**Från:** Liu, Jinsong  
**Skickat:** den 11 december 2014 12:51  
**Till:** 'avdelningS@skb.se'  
**Kopia:** Gerhardsson, Ansi; Egan, Michael; Sonnerfelt, Lena; Roland Pusch (drawrite.se@gmail.com)  
**Ämne:** kommentarer på SKB:s rapport TR-13-21  
**Bifogade filer:** SSM2014-5716-1 Kommentar på rapport\_141209\_1.pdf 715173\_1\_1.pdf

SKB has recently issued a new technical report (TR-13-21 Prototype Repository. Hydro-mechanical, chemical and mineralogical characterization of the buffer and tunnel backfill material from the outer section of the Prototype Repository). It contains several statements that are incorrect and misleading as summarized here.

| SSM 2014-5716-1                |

Fig.1. Variation in hydraulic conductivity obtained for for different samples of FEBEX bentonite versus the hydraulic gradient. After Villar, Romero and Lloret.

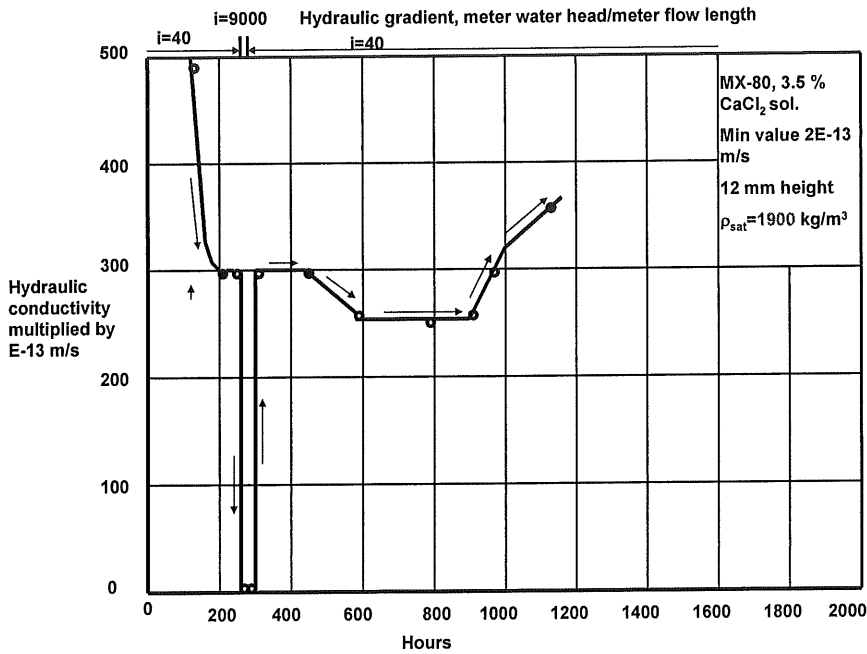
SKB has performed tests for determining the hydraulic conductivity of clay intended for surrounding the copper-lined canisters. The conductivity of samples taken from the Prototype laboratory and from equally dense, untreated clay have been compared. The problem with these tests is that the extremely high hydraulic gradient (difference in hydraulic head per flow length) changed the material and gave much too low conductivities. The gradient was 10000 meter/meter across the 1.5 cm thick samples meaning that the samples were exposed to a pressure of 150 m water head (1.5 MPa), which is known to give much too low (evaluated) conductivity values (Figs. 1 and 2). The internationally recommended maximal gradient is 30 m/m) and a recently performed by Al-Thaie at the Luleå University of Technology in Luleå and reported in his doctoral thesis (Diss. Dec. 3, 2014) University demonstrates that such high gradients underestimate the conductivity by at least 5 times (Fig.3). This discrepancy does not disqualify the KBS-3V concept but significantly reduces the safety factor of the isolating capacity of the buffer and, in particular, shows that the investigators do not realize and understand the mechanisms associated with percolation of clay materials, which imply that high hydraulic gradients cause consolidation (compression) of the clay sample and erosion of permeable channels causing clogging of them at constrictions, both leading to underestimation of the evaluated (Darcy) conductivity. The investigators' choice of such high hydraulic gradients can be taken as an attempt to deliberately demonstrate that the hydraulic conductivity is at least 5 times tighter than it actually is. If they had used a gradient of 100.000 they would have been able to show that the clay is totally impermeable.

*These studies univocally support the generally accepted rule of using significantly lower hydraulic gradients than SKB for getting relevant data of the hydraulic conductivity.*

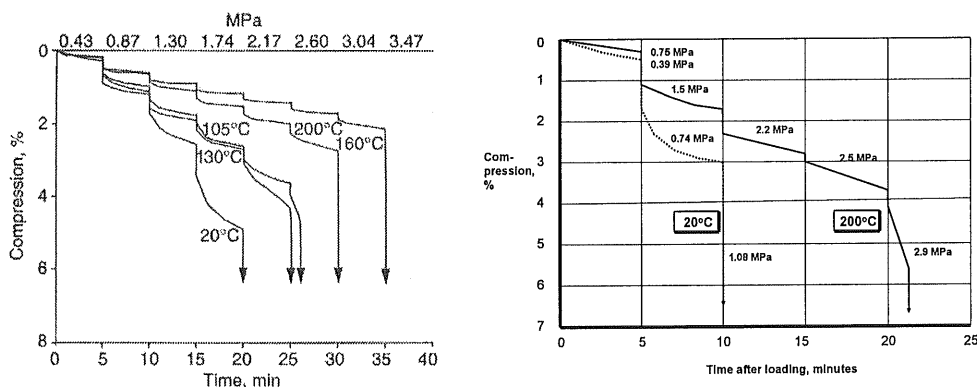
SKB knows well that stiffening of the buffer clay with time is the most threatening change that the buffer clay undergoes in a KBS-3V repository because it limits the allowed rock shear displacement that the canisters are allowed to undergo, and because it dramatically changes the self-sealing capacity of the clay caused by such impact and by channeling generated by gas percolation. A number of loading tests made by others were available to SKB when it planned and performed its experiments and they illustrate a significant stiffening by hydrothermal treatment under temperature gradients as illustrated by the graphs in Fig.4.

Fig. 5. Unconfined compression tests according to SKB's Fig. 2-24. Most "low-temperature" samples showed ductile behaviour and failed at more than 4 % strain, while the hydrothermally treated ones failed at 1.5 to 3 % and gave steeply rising and – after brittle failure – steeply dropping curves.

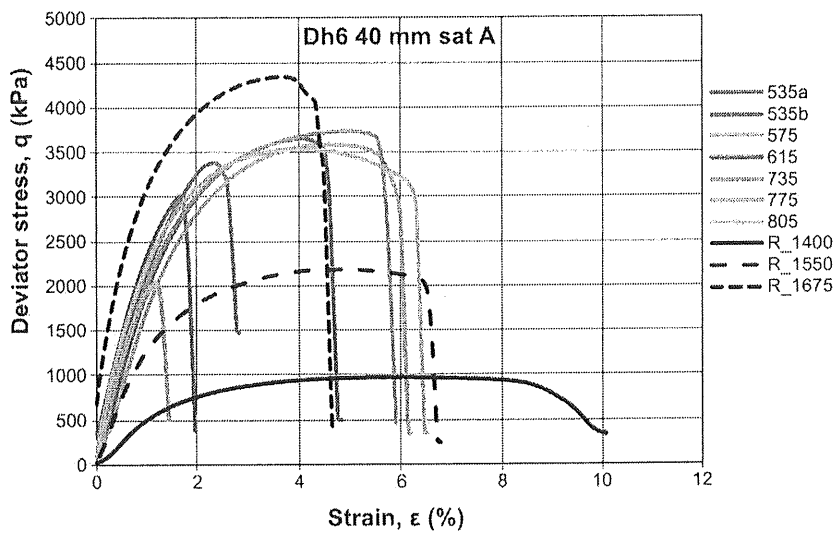
The same mistake concerns the interpretation of the unconfined compression tests and the lack of expressions of the stress/strain/time relationships and parameter data etc. The reader finds the presentation unclear and unnecessary complex but a few data can be used for drawing conclusions of the main differences between (water saturated) samples from the field experiment and from untreated ones (references) with similar density. For reference samples with a dry density of 1550 to 1675 kg/m<sup>3</sup> (1980 to 2055 kg/m<sup>3</sup> at water saturation) the axial strain at failure was 6-8 % while the hydrothermally treated sample close to the canister with a dry density of 1614 kg/m<sup>3</sup> reached the peak strength 3300 kPa at about 4.5 % strain. The discussion in section 2.4.5 gave the conclusion that there were no large differences between the behaviour of reference and hydrothermally exposed samples, which denies the fact - as for the triaxial tests - that there was an obvious and significant increase in stiffness of the latter. This was in fact even more obvious for the curves in Fig. 2-24 copied here.

Keeping in mind that the temperature was not higher than 85°C and maintained at this level for less than two years one expects that further stiffening will happen in a real repository in the thermal period of many hundred years. The risk of loss of the self-sealing capacity that is required in case of stress-generated fracturing or shrinkage of the buffer, and of critical strain of the canisters caused by the stiff buffer, is obvious (Fig. 6). The SKB authors state that other mechanisms than chemical must have led to the admitted stiffening, which hypothesis brings us to examine the chapter on chemical and mineralogical analyses of the buffer.

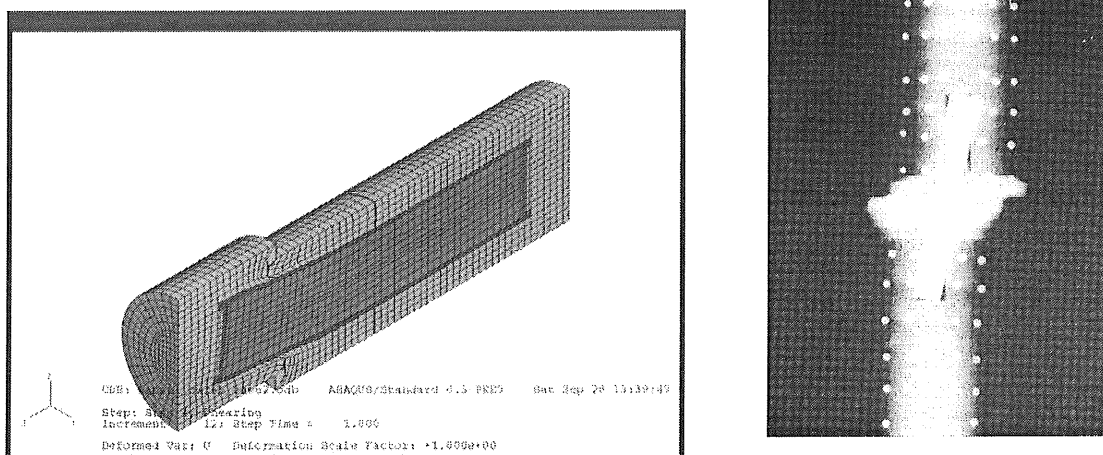
*These studies, performed by SKB and various other investigators, univocally support the conclusion that the hydrothermally treated buffer in the Prototype project stiffened considerably and that the allowed instantaneous shearing of 0.1 m will generate unacceptably high canister stresses.*

Fig. 7. Partially hypidiomorphic, pseudo-hexagonal illite-type particles in sample R8:225 (Äspö Prototype project).

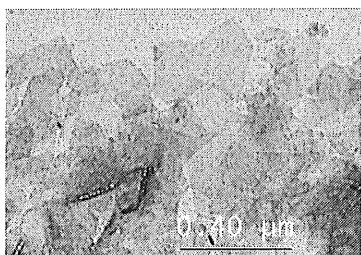
- 2) The chemical composition of the diVS-ml phases is characterized by 1) enrichment of Al in the octahedral layer, and 2) illitization (Fig. 7.). The octahedral substitution of Mg by Al reduced the deficit of charge in the octahedral layer. By dissolution/precipitation processes in the interlayer space tetrahedral Si migrated into the bulk pore solution being replaced by Al, initiating illitization. The two processes take place in chemically dynamic systems as shown by Pusch & Kasbohm (2002) and Herbert et al (2004).

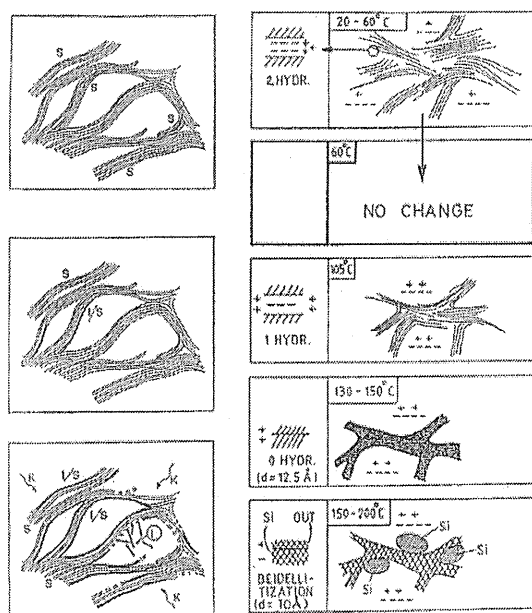
*SKB's conclusions from its chemical and mineralogical investigations were that the buffer did only undergo insignificant chemical and mineralogical changes by the exposure to hydrothermal condition. These investigations are not representative of the evolution of the buffer in a long term perspective because of 1) the short testing time, 2) the significantly lower temperature than in a real repository (applying Arrhenius-type modelling the 85°C temperature impact is much smaller than that of 100°C), and 3) the incomplete water saturation. Since thermal impact will last for several hundred years the whole concept may have to be changed so that the maximum temperature of the buffer clay is reduced to 60°C, which is believed to make it survive for a hundred thousand years without significant changes (Fig. 8).*
